# Access Compliance Report

## Public Rights-of-Way

### (Curb Ramps)

Intersection ID: 49928	Main Street: PAXTON_RUN_RD	Cross Street: CAMPBELL_HALL_CT	Location: NE
ADA ID: 250947EC7E52	Ramp Type: Perp	Initial Pass/Fail: Fail	Overall Compliance: No
Severity Score: 12.5			
Codes/Mitigation Info/Possible Solution		Field Measurements/Component Compliance

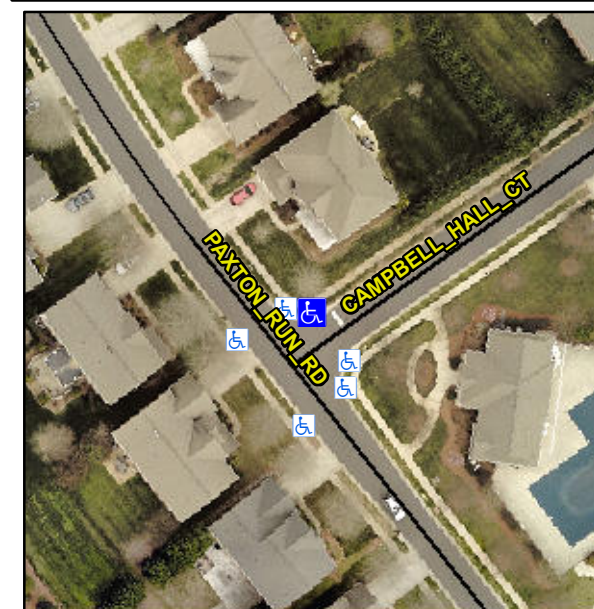
**Not Found, R304.5.3**

Compliance	Description	Data	Compliance	Description	Data
N/A	Ramp Length (in)	48.0	Yes	Ramp Slope (%)	7.9
Yes	Ramp Width (in)	48.0	No	Ramp XSlope (%)	6.0
N/A	Flare Type LT	N/A	N/A	Flare Type RT	N/A
N/A	Flare Slope LT (%)	N/A	N/A	Flare Slope RT (%)	N/A
N/A	Flare Traversable LT?	N/A	N/A	Flare Traversable RT?	N/A
N/A	Landing Length (in)	N/A	N/A	DWS Provided?	N/A
N/A	Landing Width (in)	N/A	N/A	DWS Contrast?	N/A
N/A	Landing Slope (%)	N/A	N/A	DWS Length (in)	N/A
N/A	Landing X Slope (%)	N/A	N/A	DWS Full Width?	N/A
N/A	Landing Curb? (Y/N)	N/A	N/A	DWS Offset (in)	N/A
N/A	Shared Landing?	N/A			
N/A	Gutter Ponding?	N/A	N/A	Gutter Slope (%)	N/A
N/A	Gutter Lip Ht (in)	N/A	N/A	Gutter X Slope (%)	N/A
N/A	Painted X Walk1?	No	N/A	Painted X Walk2?	N/A
	X Walk 1 Direction	To SE		X Walk 2 Direction	N/A
N/A	X Walk 1 Width (in)	N/A	N/A	X Walk 2 Width (in)	N/A
	X Walk 1 Slope (%)	0.4		X Walk 2 Slope (%)	N/A
	X Walk 1 X Slope (%)	5.0		X Walk 2 X Slope (%)	N/A

**Remove & Replace Entire Ramp.**
